## ADDENDUM NUMBER ONE

### DUPONT PUMP STATION AND BASIN IMPROVEMENTS – PHASE 2 (Contract A) W-12-026-202

#### CITY OF CHATTANOOGA, TENNESSEE

SHEET: C-17

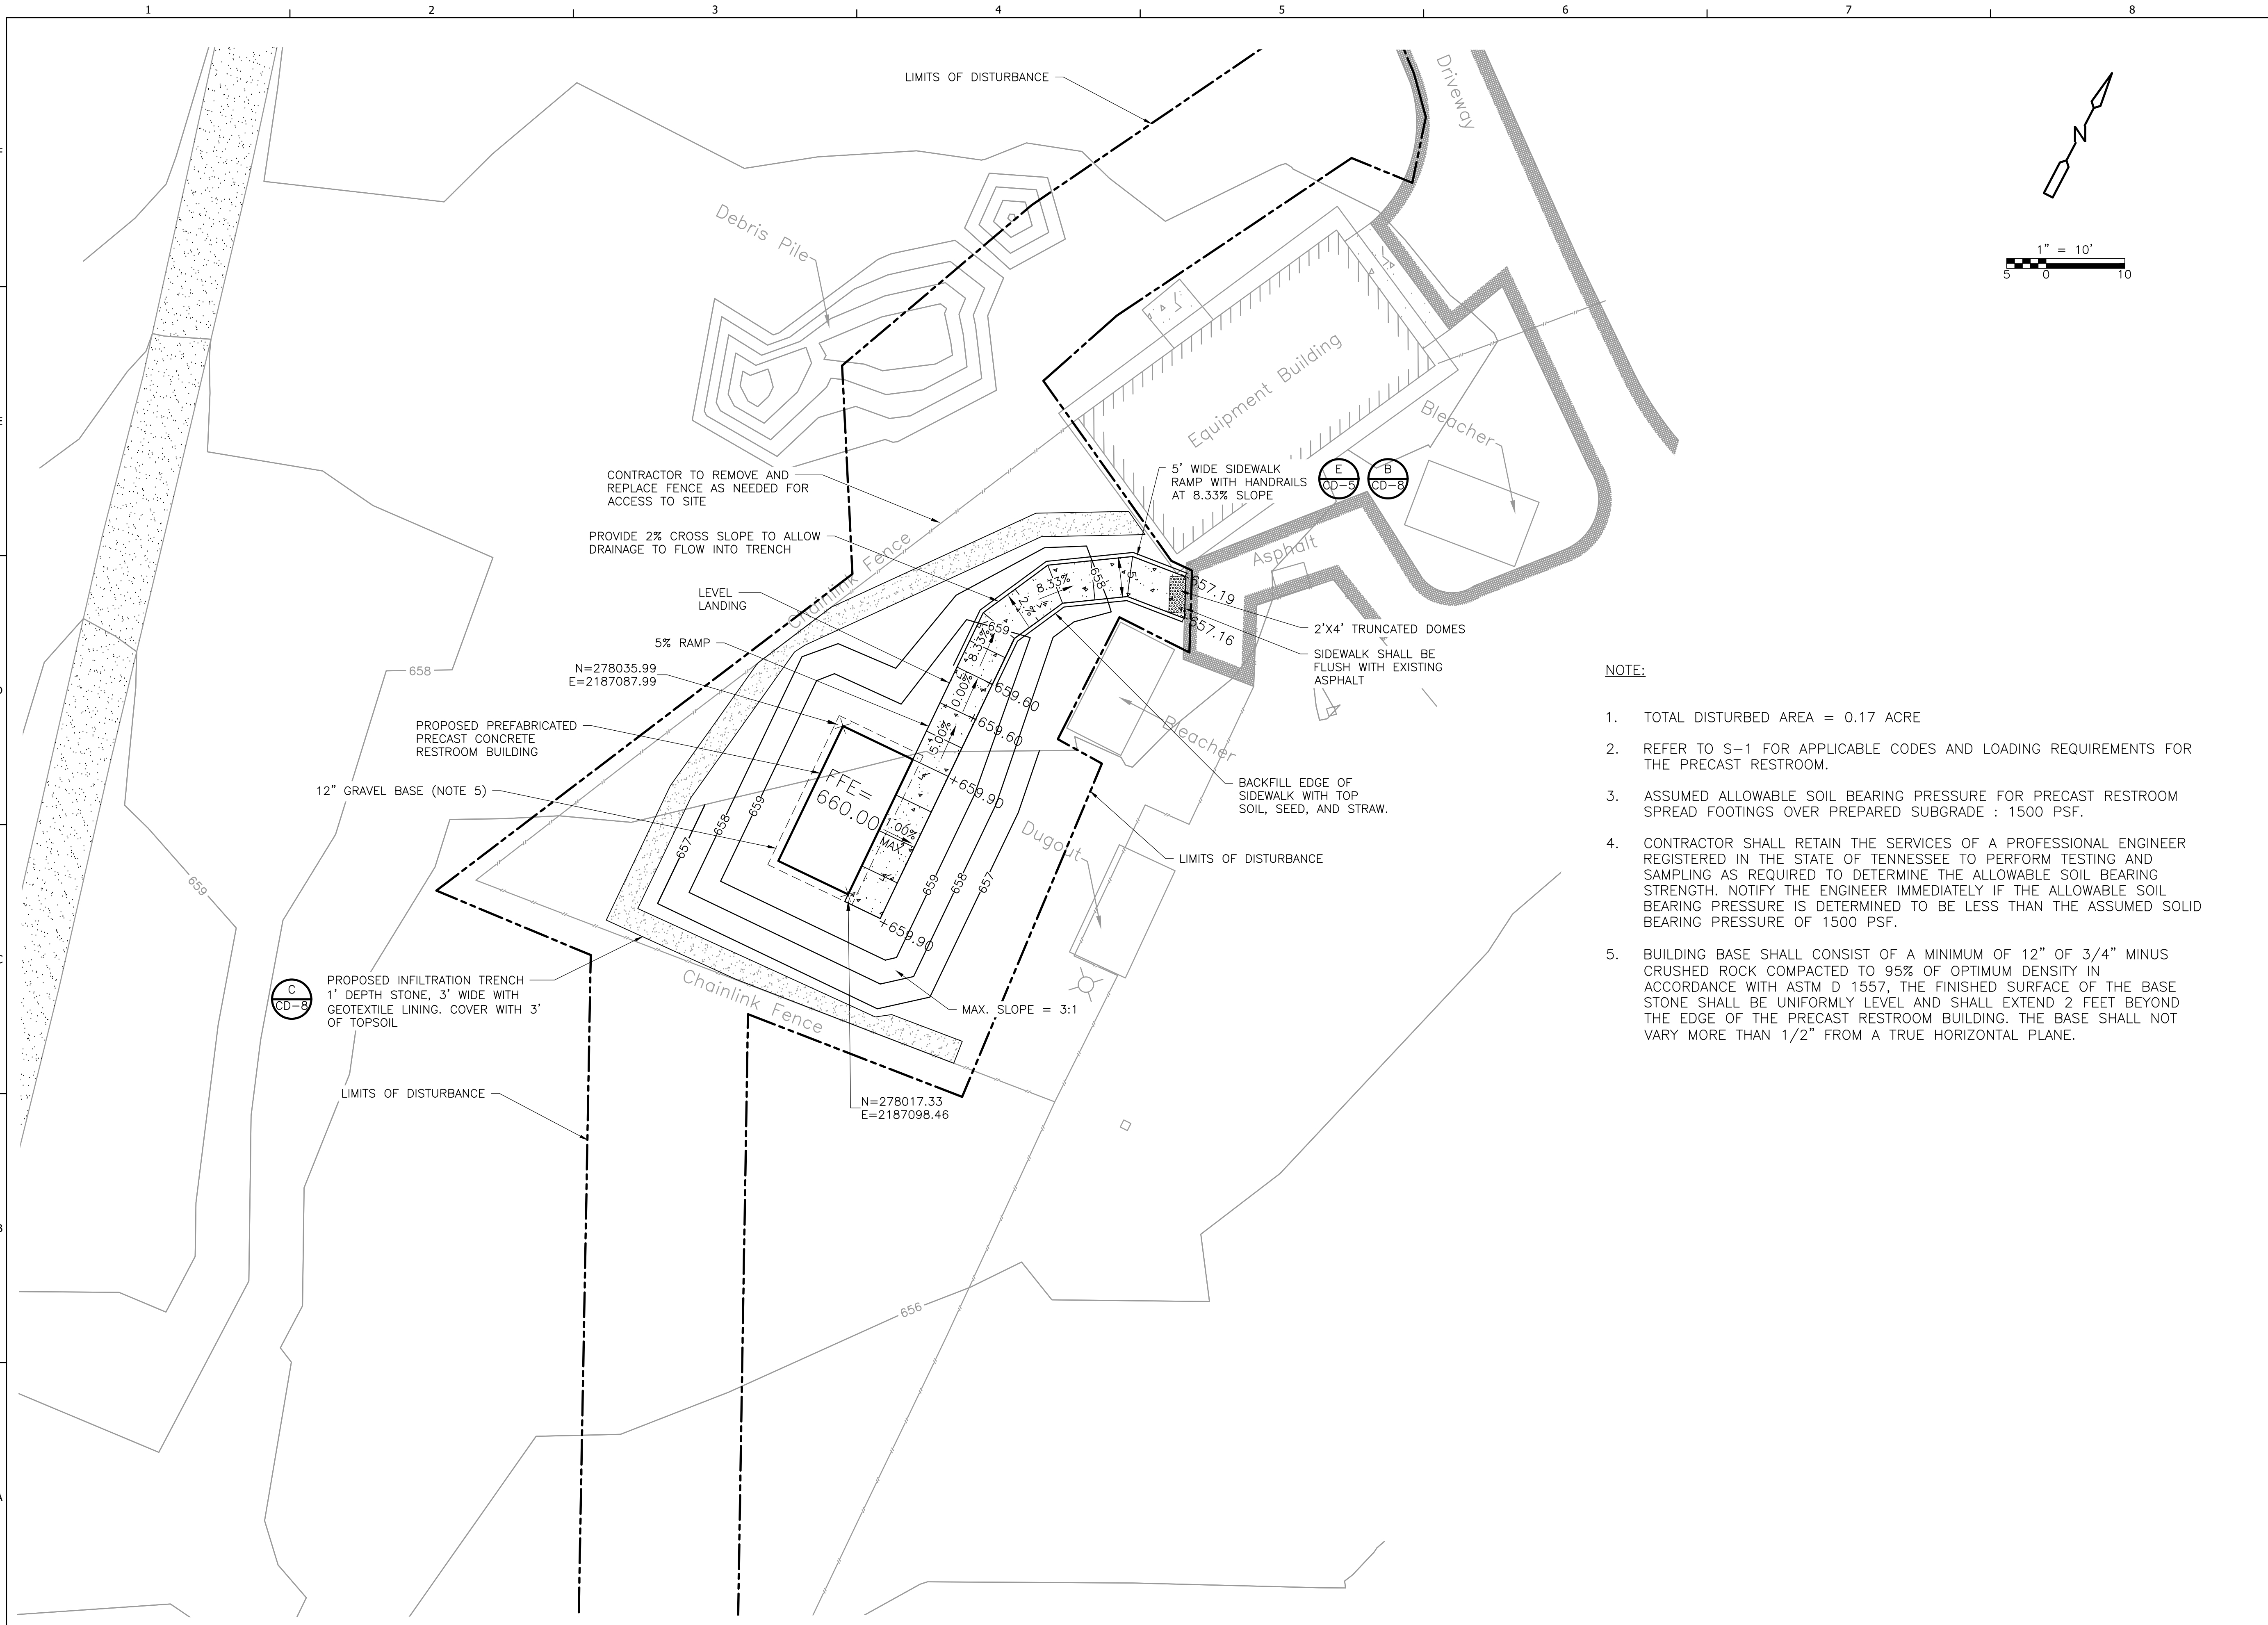
- A copy of the sign-in sheet from the Pre-Bid meeting on November 21, 2019 is attached.
- Add attached Drawings C-17, C-18, C-19, C-20, and CD-8.
- Add attached Specification Section 13 60 13 Pre-Fabricated Restroom
- Replace Section 00 41 00 Bid Form with the attached.
- Drawing C-1: Revise Laydown Area Label “Contractor Laydown Area 60’x175”
- Drawing C-4: Revise RCP Label “12” RCP” for both stormwater pipelines located between the new catch basins and new concrete headwall.
- Add Wilo and Ebara to the list of acceptable submersible solids handling pump manufacturers. Product shall meet the detailed requirements of the specifications.
- Add Lord and Company to the list of acceptable PCSS in Section 40 90 00.
- Replace paragraph 2.03.D in Section 43 21 39 with the following paragraph:
